January 22, 2015

01273 Version 1

Rattle from the Second Row Passenger Seat on Rough Roads

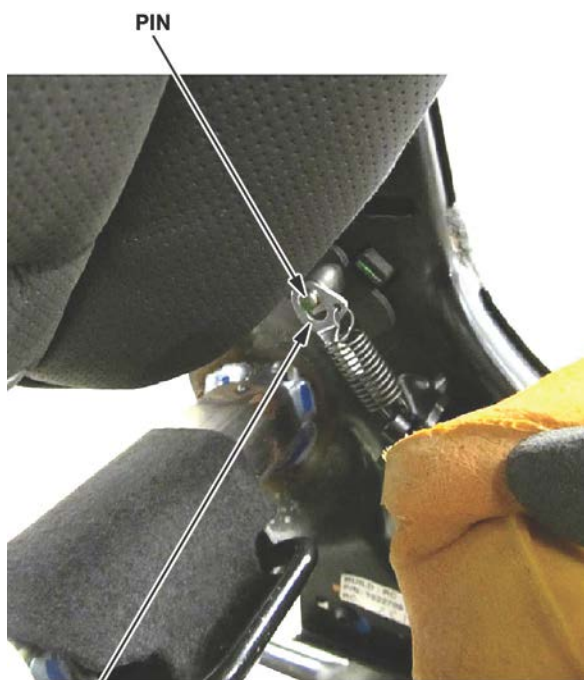
7. Inspect the spring and how it is hooked on the clip.

- If the spring eyelet is on the rear side of the clip, this bulletin does not apply.

- If the spring eyelet is on the front side of the clip, go to step 8.

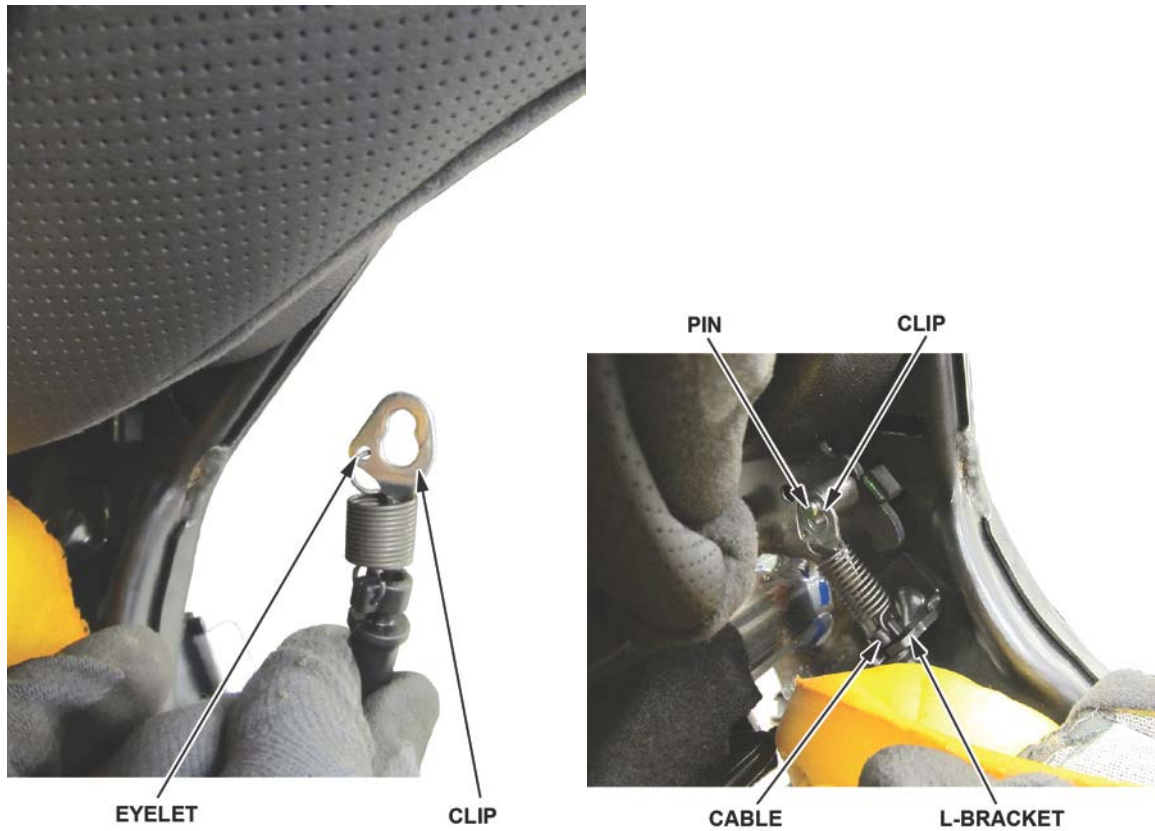
8. Remove the cable from the L-bracket on the frame.

9. Remove the clip from the pin.

10. Rotate and reattach the clip so that the eyelet is now facing to the rear of the seat, then reattach the clip to the pin and the cable to the L-bracket.
